Response to the comments from Reviewer #4

Figure R1. The spatial distribution of average yearly precipitation (mm).

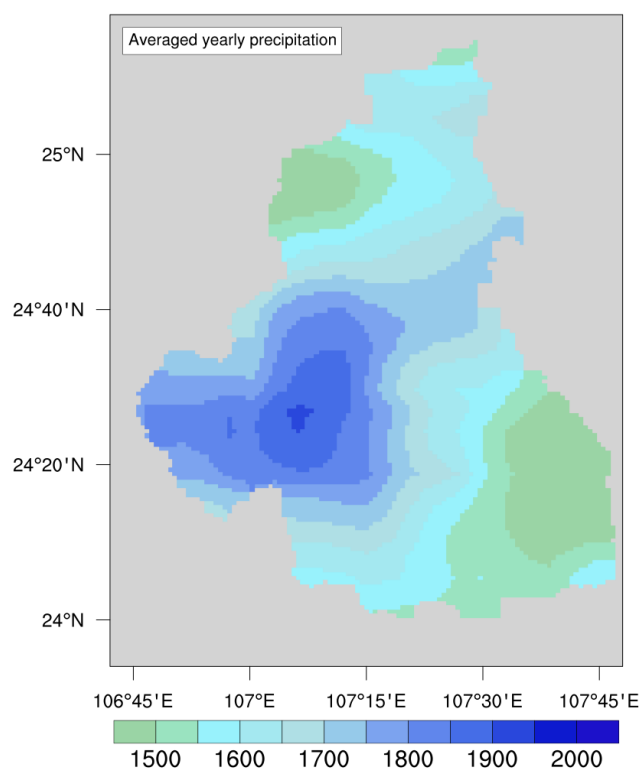
5) Lines 283-290: *“For the downstream areas with less precipitation, the higher NSE is related to the higher percentage of sand in the soil (not shown).” I doubt whether the higher NSE downstream can be explained by the spatial distribution of the sand proportion. In Figure R2, the downstream sand proportion shows a large spatial variability which is not consistent with the spatial pattern of NSE in Figure 3. It also confuses me that the higher sand content is related to better performance of the hydrological model, which seems to be contrary to the fact that the model performs better in wetter areas where the sand content is not very large. Please clarify.*

Response: Thanks for the comments. The higher NSE in the downstream areas can be explained by two portions. In the Jiazhuan region (the southwest region of the basin), the performance is good because of more precipitation and not very large sand contents, which is consistent to the provided fact (Figures R1, R2). The south and southeast regions have similar precipitation as the northern region. With more sand portion, rainfall in such region will infiltrate easier, and yields less runoff under infiltration excess, which is more suitable for the saturation excess-based runoff scheme in the CSSPv2 model, and shows a better performance against the northern grids.
